RIV090903 Response to Comments Memorandum

The purpose of this memorandum is to address comments that were raised in the June 22, 2025 letter from the San Geronio Chapter of the Sierra Club (Attachment 1).

RE: Item 4.1-4: RIV090903 - Cajalco Road Widening and Safety Enhancement Project – SCH #2011091015;

Figure 1. Future project locations from RCTC Long-Range Transportation Study (2019). The alignment of the Cajalco Road project is the location of the CETAP state highway ID: 3C01MA01 – project 1 in Appendix A.

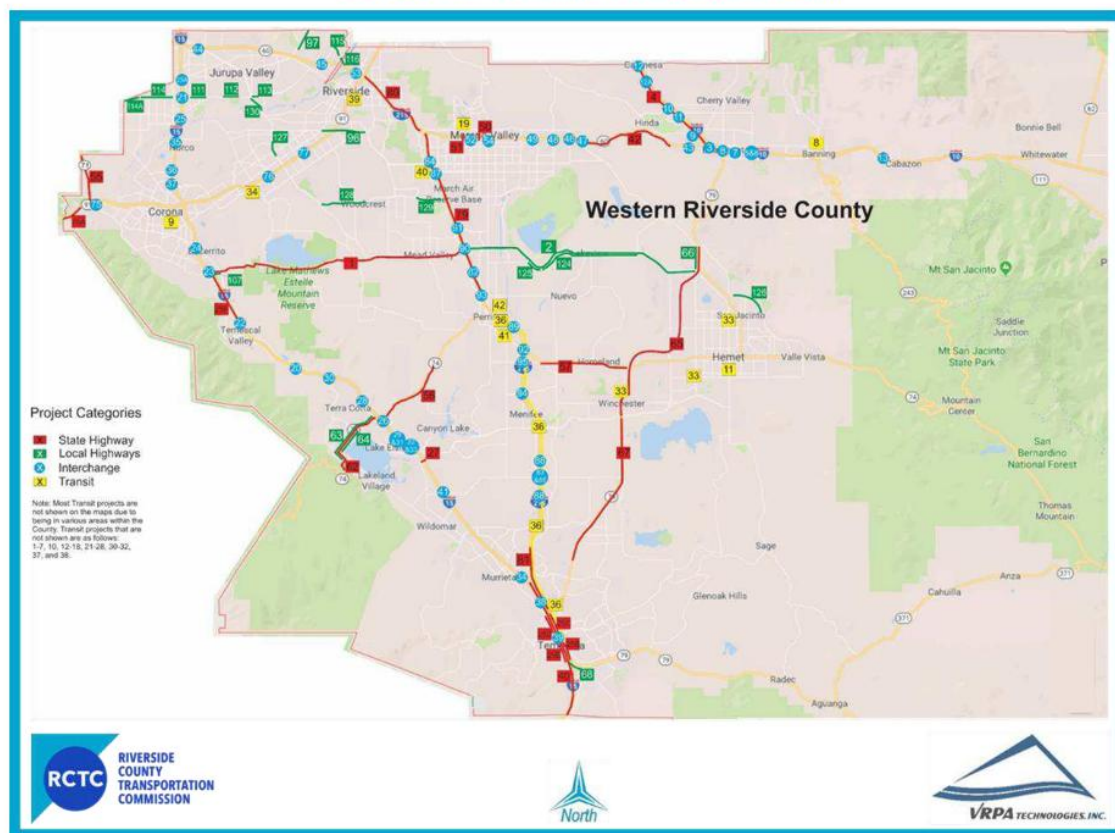
Figure 1 (red line – project 1) shows the alignment of the CETAP east-west highway from the RCTC 2019 Long Range Transportation Study. The CETAP alignment is identical to the proposed Alternative 1 from the Cajalco road widening project; it is NOT a separate parallel facility. It is the long-term 6-lane state highway version of the current proposed 4-lane project. There are no other long-term projects shown in the long-term strategic plan that are a separate parallel facility.

The traffic analysis for the project DEIR and the conformity analysis is **double-counting** the Cajalco road widening and CETAP facility as separate projects and is therefore underestimating future traffic volumes. Please redo all the traffic analysis for this project that double counts traffic volumes using inaccurate RIVCOM model inputs. All traffic analysis that includes the ‘CETAP corridor analysis’ is invalid. Only the ‘Without CETAP corridor’ analysis is possible, with the corresponding higher traffic volumes as shown in **Table 3.6-16** from the DEIR; these traffic volumes are and Level-of-Service ratings are higher and more congested than those identified in Table 2 in the TCWG Project summary. Truck volumes will increase by between 80-350% along the new route with thousands of extra truck trips daily.

Response #1. The Traffic Operations Validation Memorandum (Iteris, June 2, 2025) that was prepared for the Project included a supplemental traffic analysis for the Cajalco Road Widening and Safety Enhancement Project at key intersections along Cajalco Road. This supplemental analysis was performed to validate the traffic results included in the Draft Environmental Impact Report/ Environmental Impact Statement (DEIR/EIS). The analysis utilized traffic counts collected in 2025 to establish the current traffic conditions. The design year (2048) scenario in the analysis utilized the most up-to-date travel-demand forecasting model employed in the County of Riverside, to evaluate traffic, which is the Riverside County Model (RIVCOM). Using RIVCOM, traffic forecasts were developed assuming that the CETAP facility (both the portions located west of I-215 and east of I-215) would not be built, to determine the impact on traffic along Cajalco Road should CETAP not be constructed. Thus, traffic intended for Cajalco Road would not be re-routed to other high-capacity facilities, presenting a more realistic projection of future volumes. The results of the LOS evaluation showed that the new future year 2048 with project traffic operations are projected to generally be consistent with the LOS results projected in the 2021 DEIR/EIS’s future year 2044 with project scenario, with overall vehicle delay lower than those presented in the 2021 DEIR/EIS.

Figure 3. Warehouse projects and industrial rezones within a few miles of the terminus of the Cajalco project. Data on Foundation General Plan Amendments from Planning Department.⁶

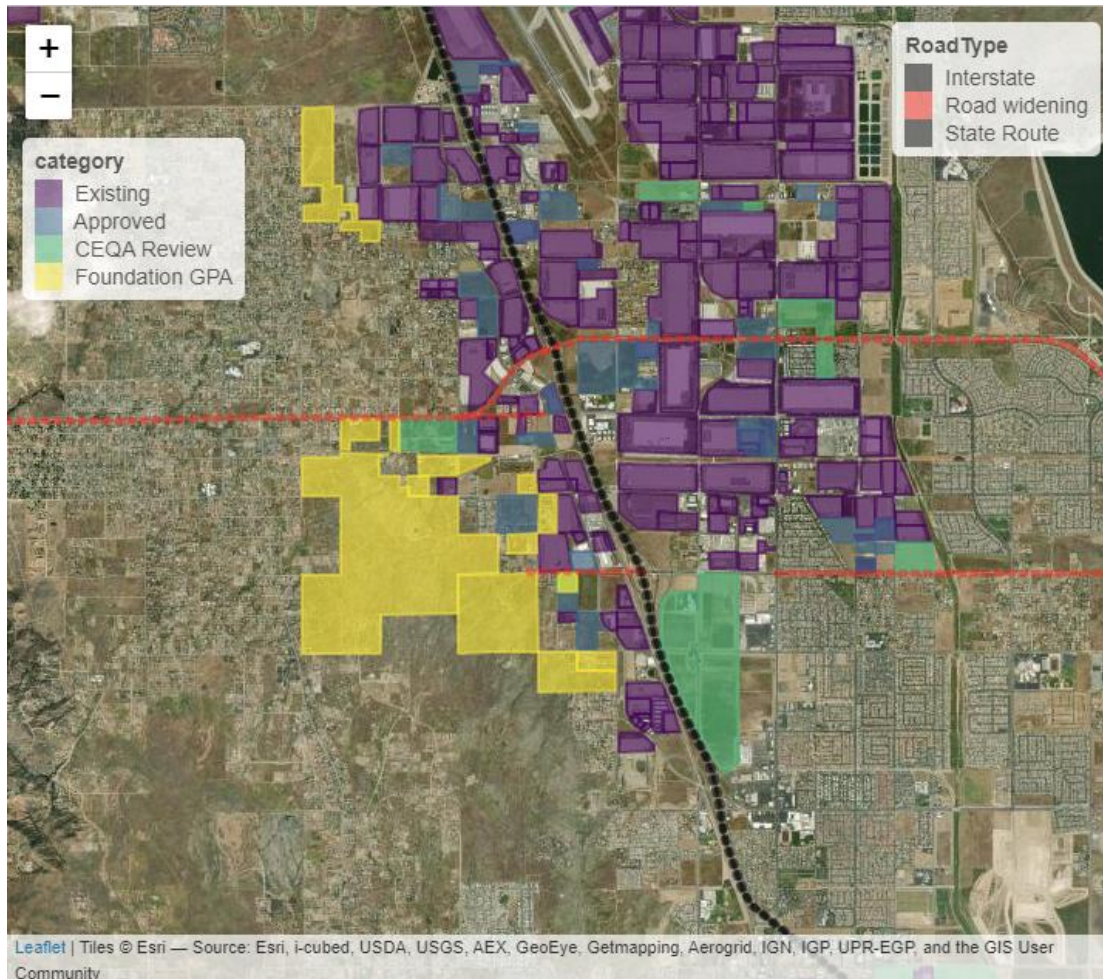
- 2) Significant additional warehouse growth is planned on the eastern terminus of the project, at least partially because of the long-planned Cajalco roadway expansion. Figure 3 shows existing, approved, under CEQA review, and under County pre-review projects along the Cajalco – I-215 terminus. Thousands of acres of land are being rezoned from residential to industrial along this roadway and the adjacent Mid County Parkway. A reasonable list of projects to include that are ‘cumulatively considerable’ and ‘reasonably foreseeable’ within 2 miles of the project include:

- 1) Warehouse growth on the eastern terminus of the project has more than doubled the footprint of warehouses within 3 miles of the Cajalco-215 on-ramp from ~36M SQ FT in 2014 to over 79M SQ FT in 2025⁴. This has more than doubled truck volumes on I-215.
- 2) Significant additional warehouse growth is planned on the eastern terminus of the project, at least partially because of the long-planned Cajalco roadway expansion. **Figure 3** shows existing, approved, under CEQA review, and under County pre-review projects along the Cajalco – I-215 terminus. Thousands of acres of land are being rezoned from residential to industrial along this roadway and the adjacent Mid County Parkway. A reasonable list of projects to include that are ‘cumulatively considerable’ and ‘reasonably foreseeable’ within 2 miles of the project include:
 - a. Harvest Landing (SCH# 2024080337) – 288 acres of warehouses

Response #2. Recent growth in land use (such as warehousing) between 2014 and 2025 is captured in the Traffic Operations Validation Memorandum, referenced in Response #1, using recently collected 2025 intersection traffic counts. These traffic counts included separate truck counts, which have been accounted for using a truck percentage per vehicle movement in the Synchro (traffic analysis) software used to calculate intersection levels of service (LOS). Further, to account for projected/planned warehouse growth in the design year 2048 scenario, the RIVCOM model was utilized. RIVCOM is the current travel-demand forecast model used in the County.
